500 TERRY AVENUE

RECOMMENDATION MEETING

DPD #3012929 | DECEMBER 12, 2012

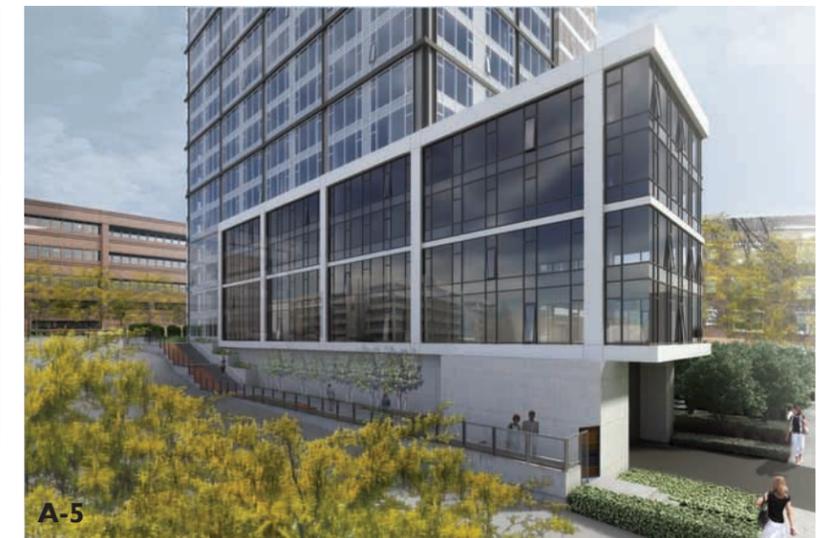
A-4 <i>Human Activity</i>	New development should be sited and designed to encourage human activity on the street.	The design of the streetscape should consider the needs of the various constituents who live and work in the neighborhood.	Neighborhood employees, residences and others will benefit from the corner open space being designed to engender a welcoming, transparent experience for all.
A-5 <i>Respect for Adjacent Sites</i>	Buildings should respect adjacent properties by being located on their sites to minimize disruption of the privacy and outdoor activities of residents in adjacent buildings.	The applicant requested a departure for upper level setbacks along the adjacent parcels. The Board requested further investigation of whether the granting of the departure imposes constraints on potential surrounding development. Adjustment to the proposal's floor and unit sizes may make the request unnecessary. Applicants note: The Applicant also requested a set back on Jefferson street (holding back from the property line 0' rather than 10'). The board was supportive of this departure.	Due to the prescriptive code's significant setback of 20' above the podium, the applicant still needs this departure (holding back from the property line 15' rather than 20'). The four podium floors are now being held back 15' from the property line rather than the 7' prescribed and aligning with the tower above. This will provide relief. The length of the block allows a second, similar tower to overlap only about 42 feet, although the adjacent property owner is considering a low-rise (6-story) residential development which would benefit from the proposed 15' setback elevation upward rather than the code minimum of 7' up to a 45' height. Additionally, the applicant has met with the property owner to the North and East and the two parties have an agreement that supports the applicant's requested departure. Drawings are being provided at the recommendation presentation.

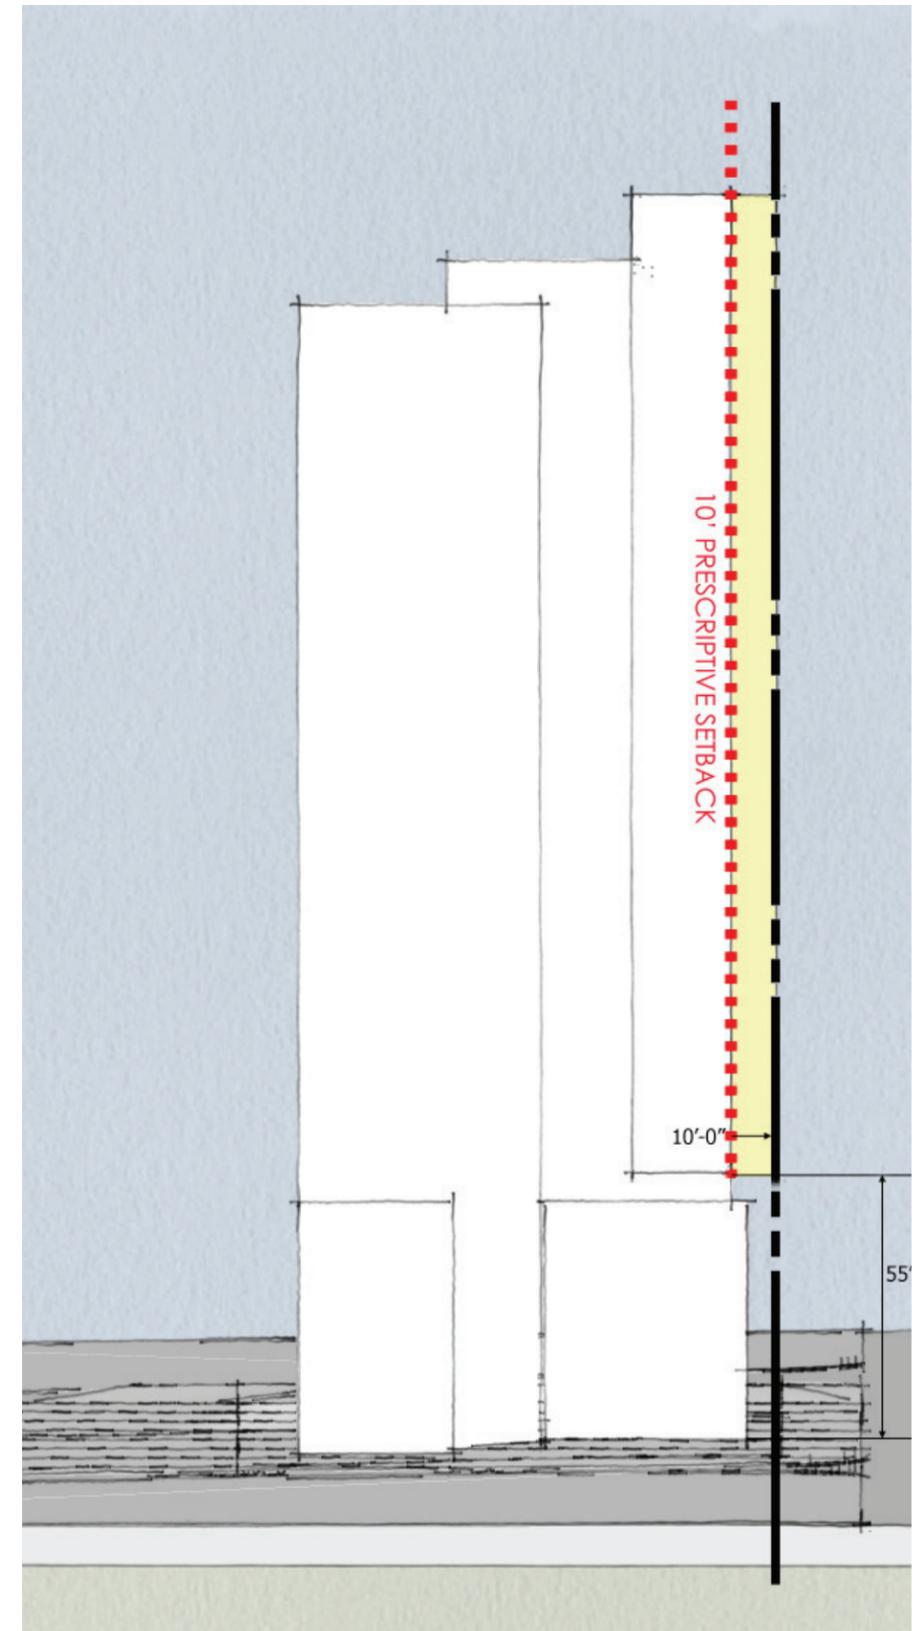
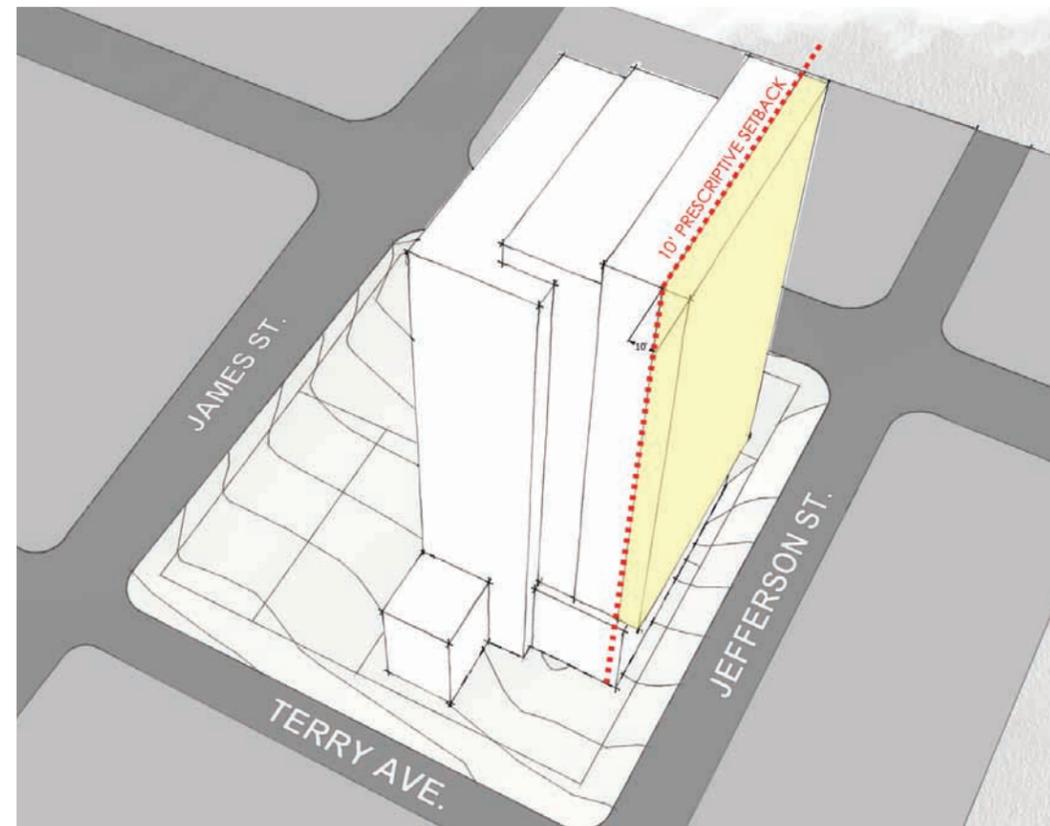
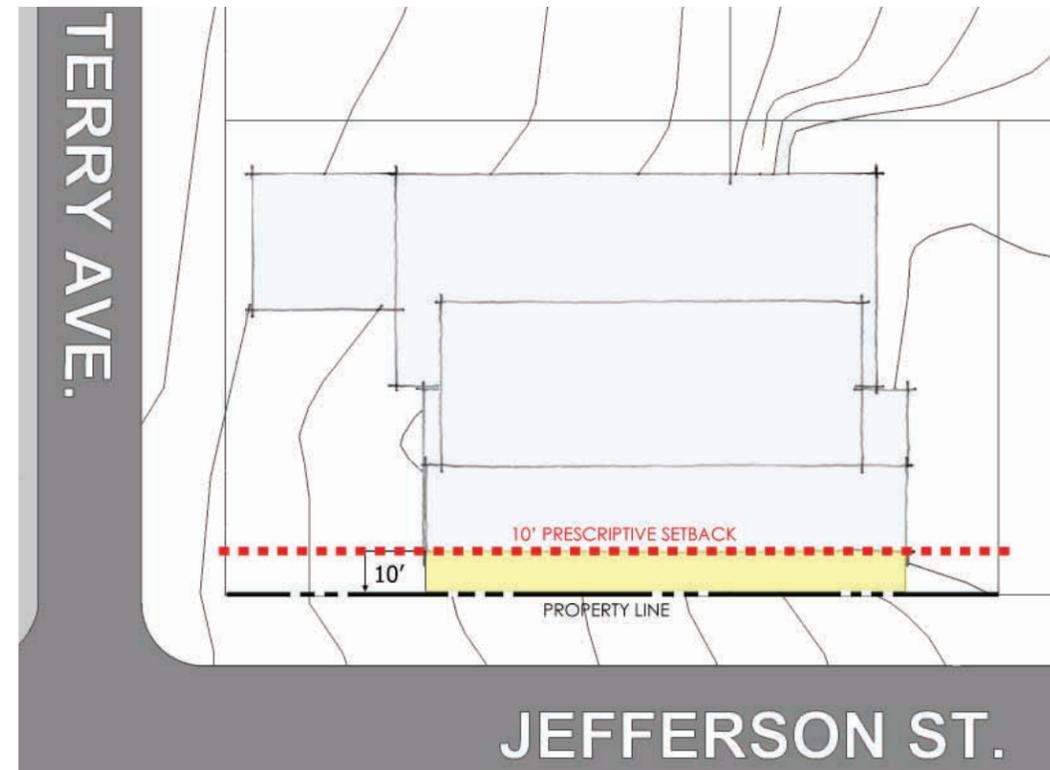
DEPARTURE:	ONE
DEVELOPMENT STANDARDS	SMC 23.45.518 HR SETBACKS
PRESCRIPTIVE	At lot lines abutting the street: Portions above 45': 10' minimum setback
PROPOSED	At lot lines abutting the street: Portions above 55': 0' setback
CONSIDERATIONS	Slenderizes the building in the East-West direction. Allows for a 10' podium setback

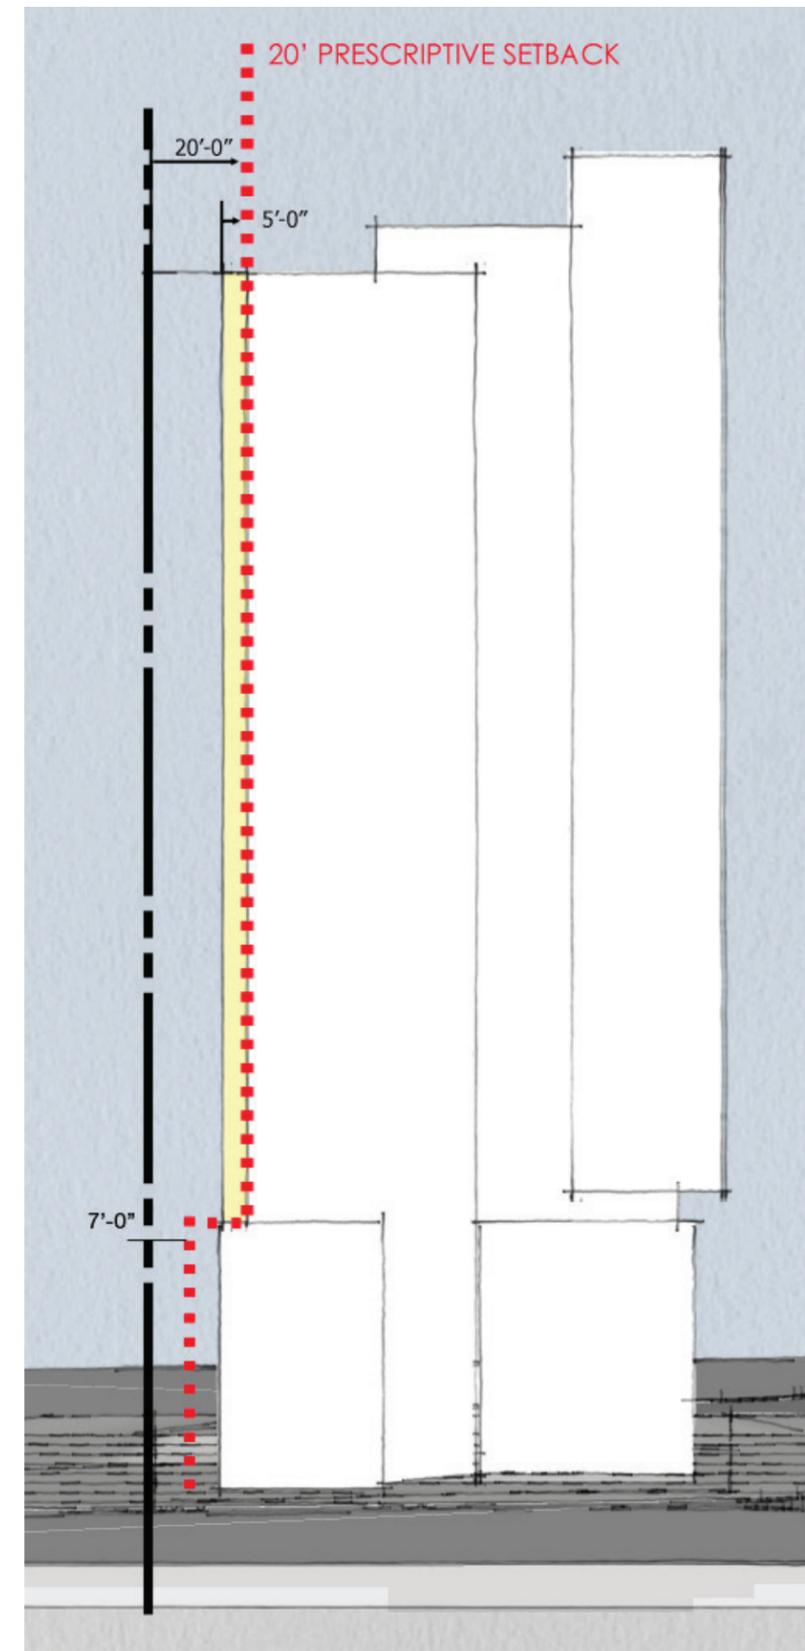
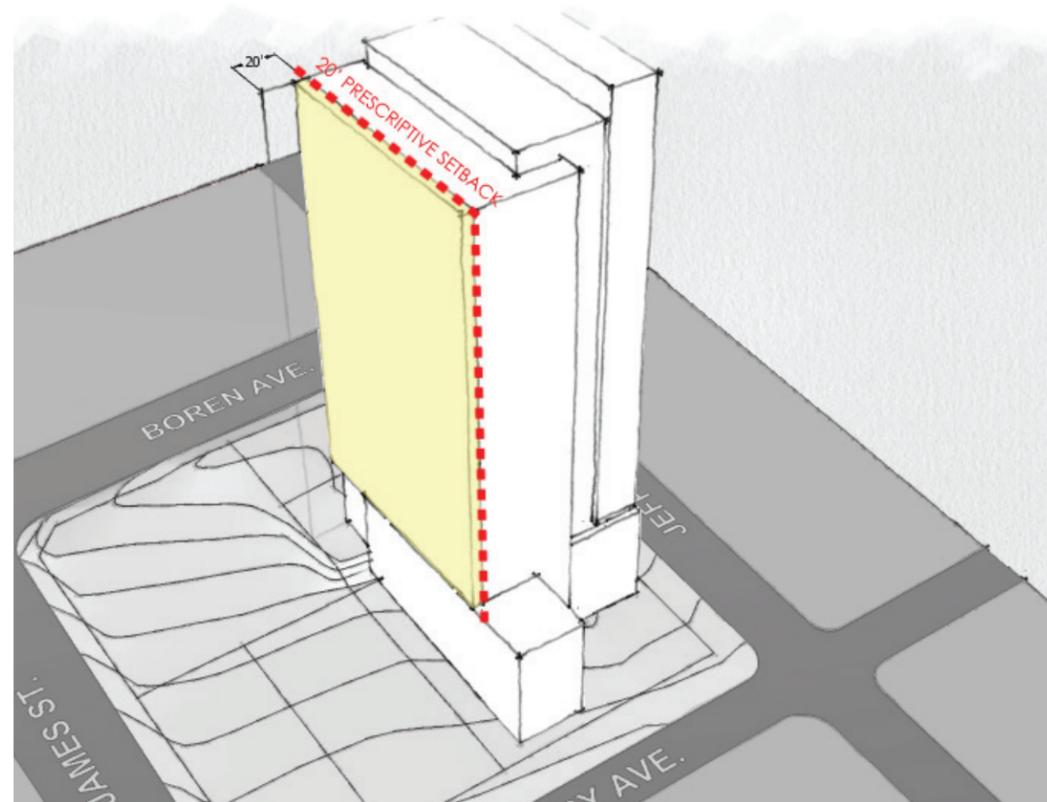
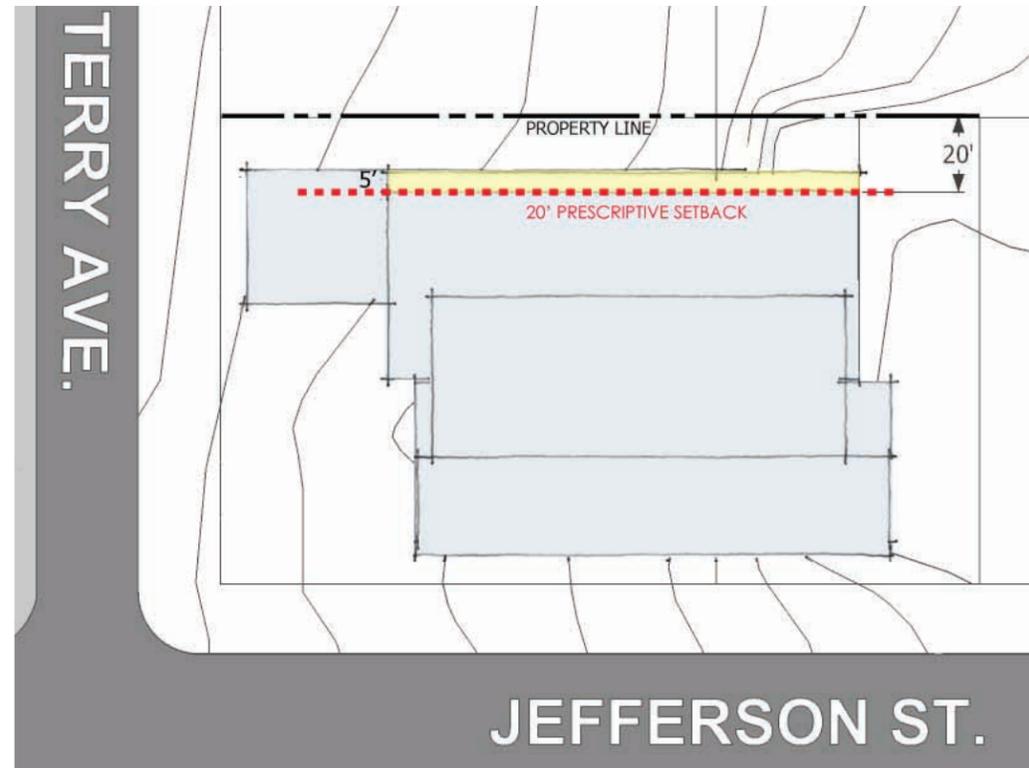
ITEM #	TWO
DEVELOPMENT STANDARDS	SMC 23.45.518 HR SETBACKS
PRESCRIPTIVE	At lot lines abutting neither a street nor alley: Portions above 45': 20' minimum setback
PROPOSED	At lot lines abutting neither a street nor alley: Portions above 45': 15' minimum setback
CONSIDERATIONS	Slenderizes the building in the East-West direction and provides 15' setback below 45' versus the code minimum 5' setback and 7' average.

NEIGHBORING PROPERTY GARAGE ENTRY

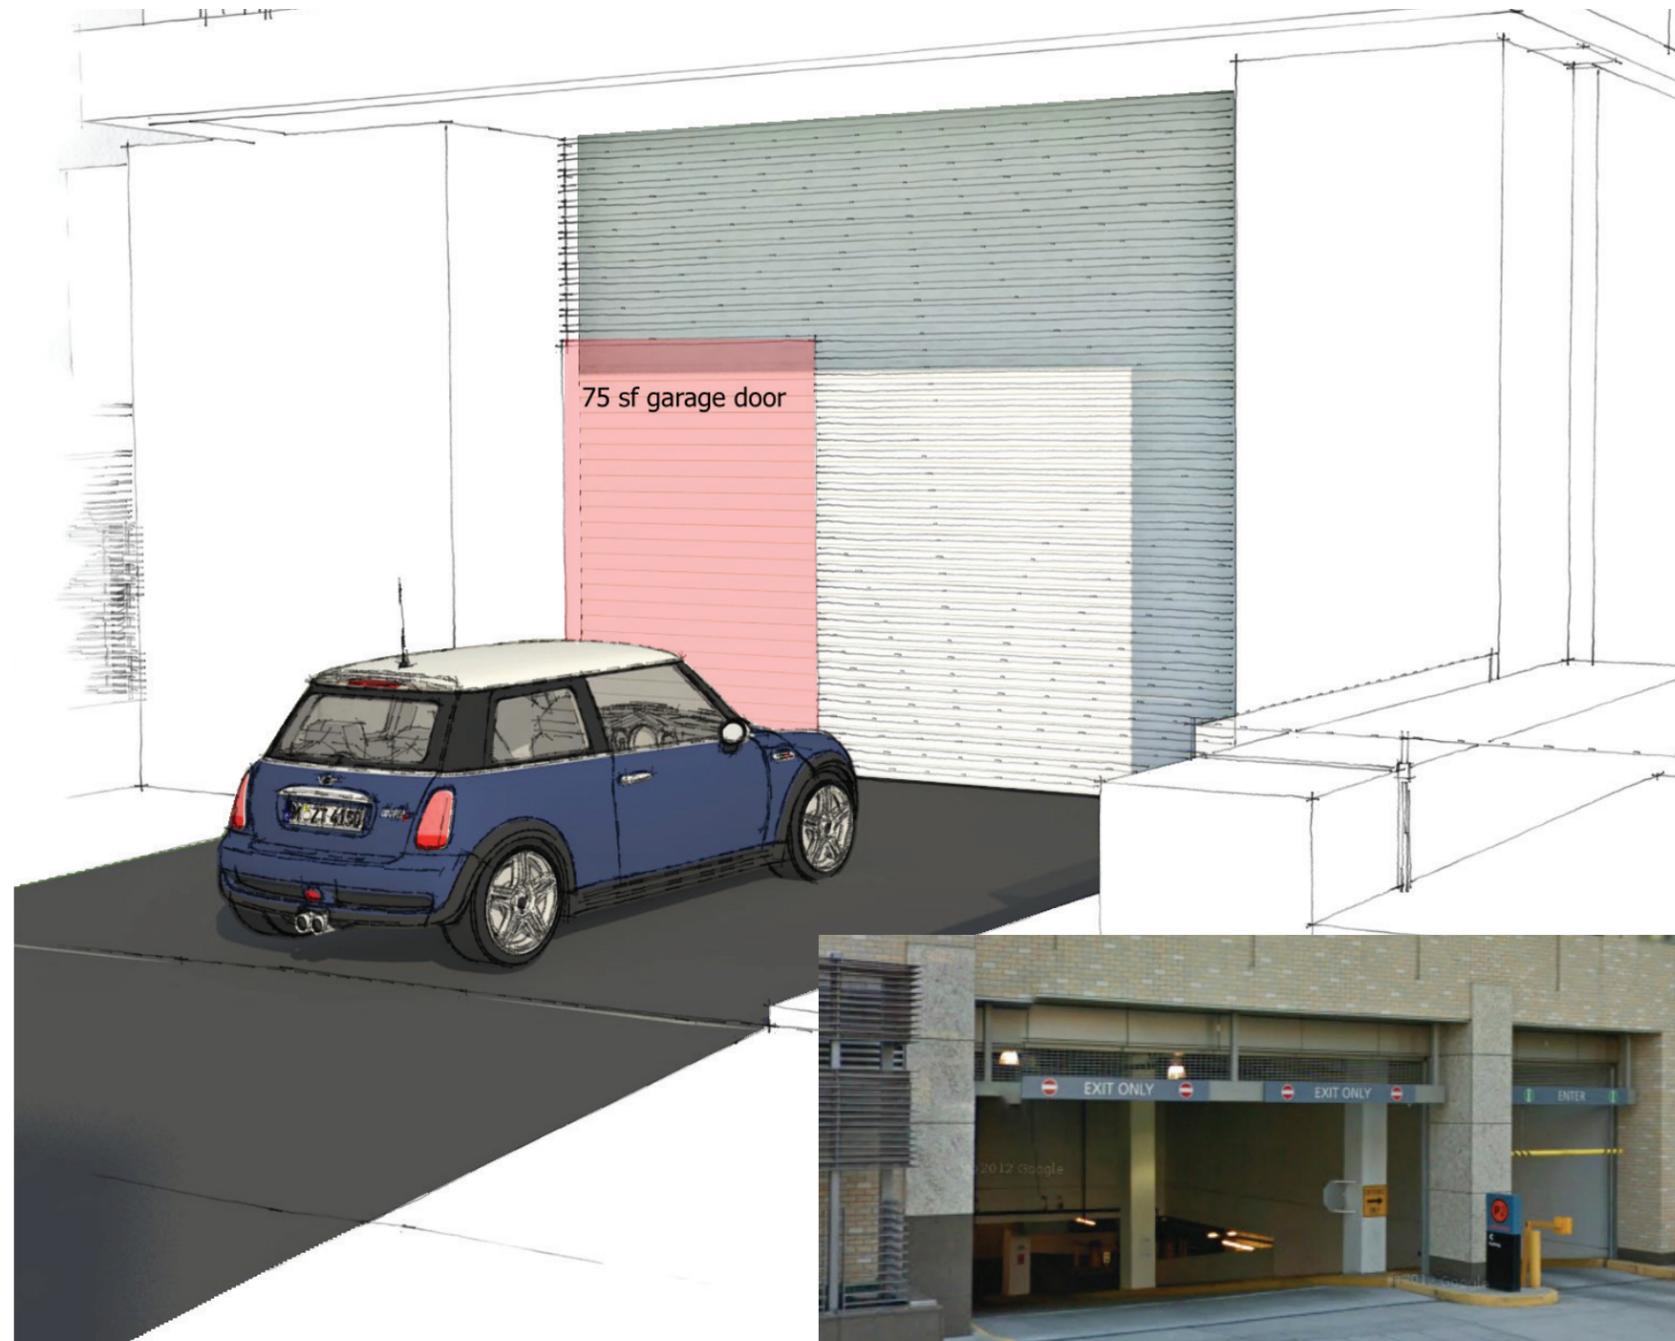
ITEM #	THREE
DEVELOPMENT STANDARDS	25.45.536.D.3.a
REQUIREMENT	Garage doors may be no more 75 square feet in area.
PROPOSED	Garage door is proposed to be 300 square feet in area.
CONSIDERATIONS	To allow for the required two-way traffic into the parking garage; the door is required to be 21 feet in width. To allow for service vehicles, the door must be 15 feet in height.
